Notification# 20170117004
Datasheet for TLV2217
Information Only

PCN Number:	20170117004	**PCN Date:**	Feb. 17, 2017
Title:	Datasheet for TLV2217		
Customer Contact:	PCN Manager	**Dept:**	Quality Services

SLVS067M – MARCH 1992 – REVISED NOVEMBER 2016

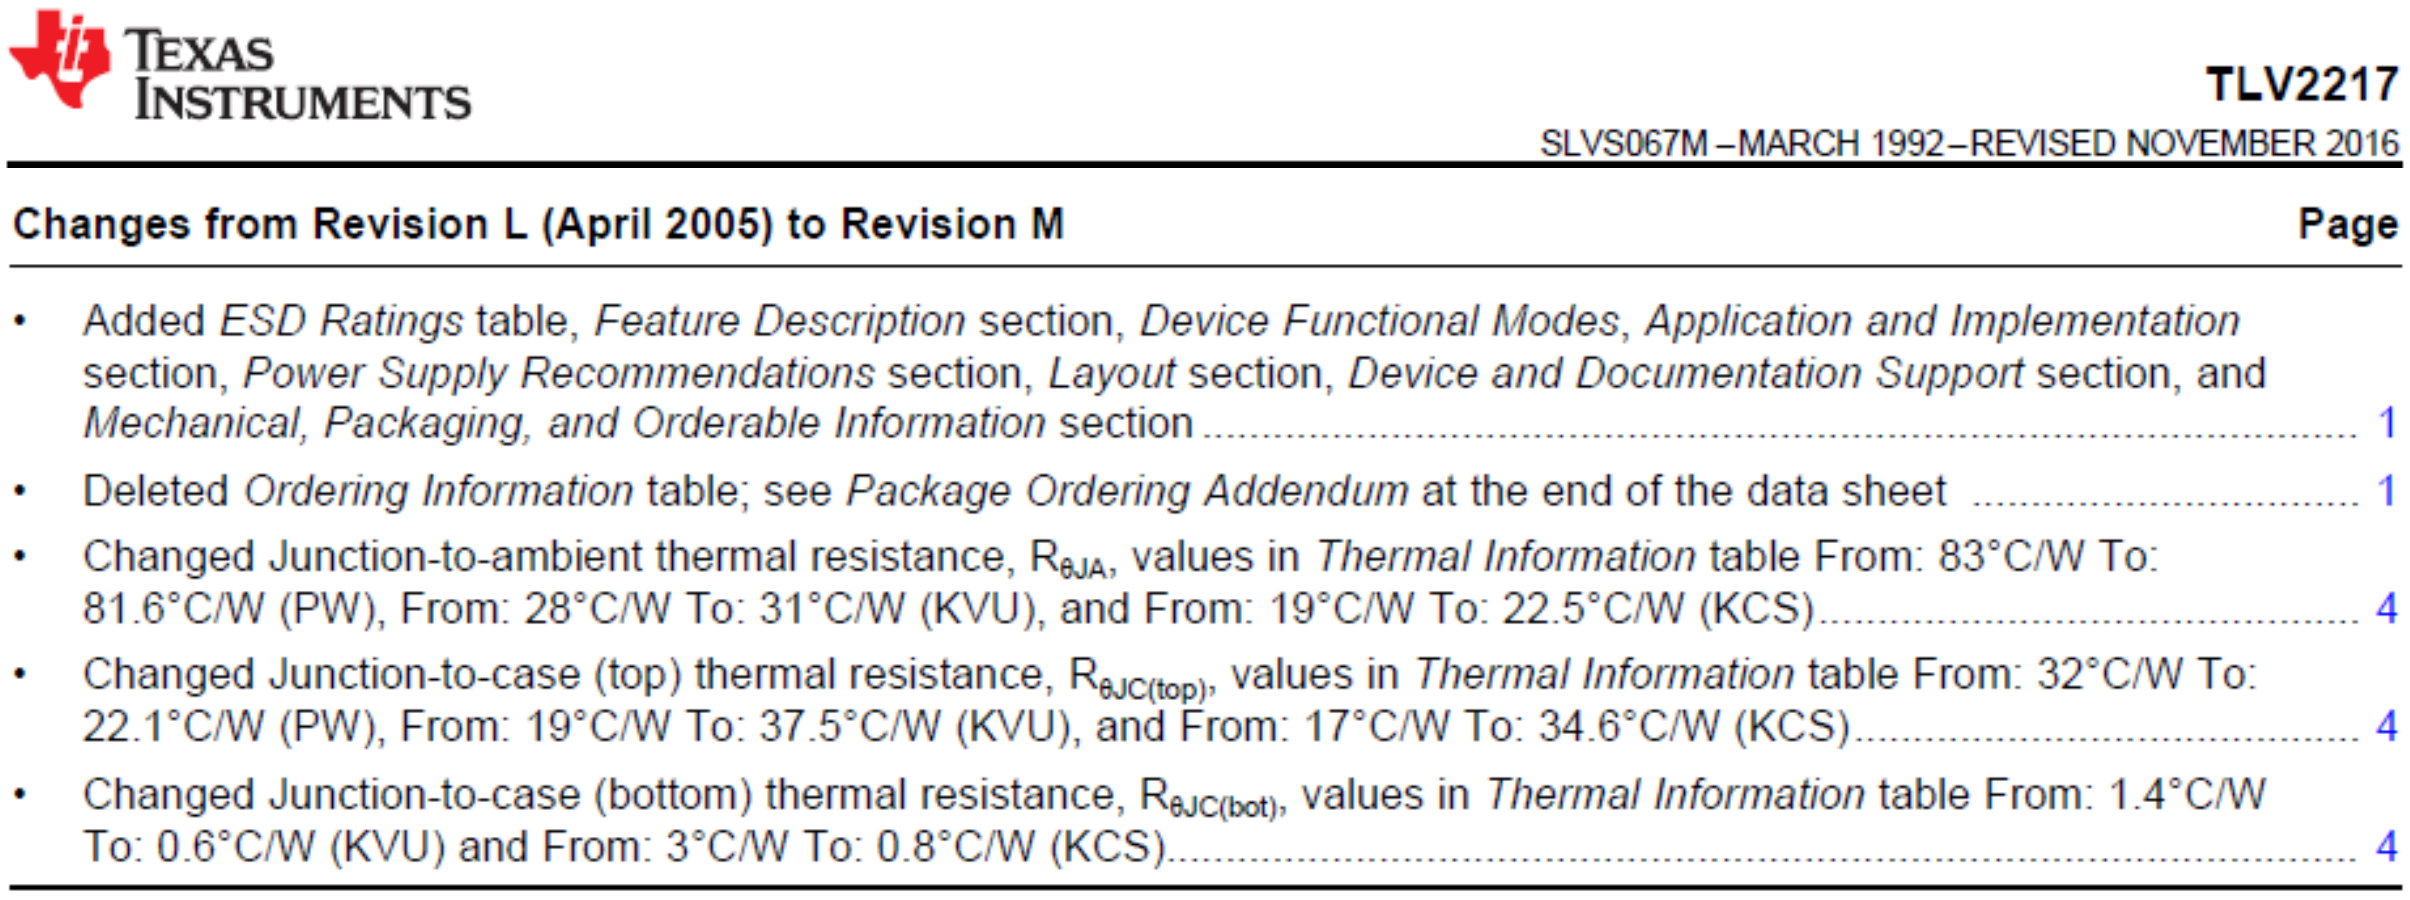
Changes from Revision L (April 2005) to Revision M	**Page**
• Added *ESD Ratings* table, *Feature Description* section, *Device Functional Modes*, *Application and Implementation* section, *Power Supply Recommendations* section, *Layout* section, *Device and Documentation Support* section, and *Mechanical, Packaging, and Orderable Information* section	1

• Deleted *Ordering Information* table; see *Package Ordering Addendum* at the end of the data sheet	1
• Changed Junction-to-ambient thermal resistance, $R_{\theta JA}$, values in *Thermal Information* table From: 83°C/W To: 81.6°C/W (PW), From: 28°C/W To: 31°C/W (KVU), and From: 19°C/W To: 22.5°C/W (KCS)	4

• Changed Junction-to-case (top) thermal resistance, $R_{\theta JC(top)}$, values in *Thermal Information* table From: 32°C/W To: 22.1°C/W (PW), From: 19°C/W To: 37.5°C/W (KVU), and From: 17°C/W To: 34.6°C/W (KCS)	4

• Changed Junction-to-case (bottom) thermal resistance, $R_{\theta JC(bot)}$, values in *Thermal Information* table From: 1.4°C/W To: 0.6°C/W (KVU) and From: 3°C/W To: 0.8°C/W (KCS)	4
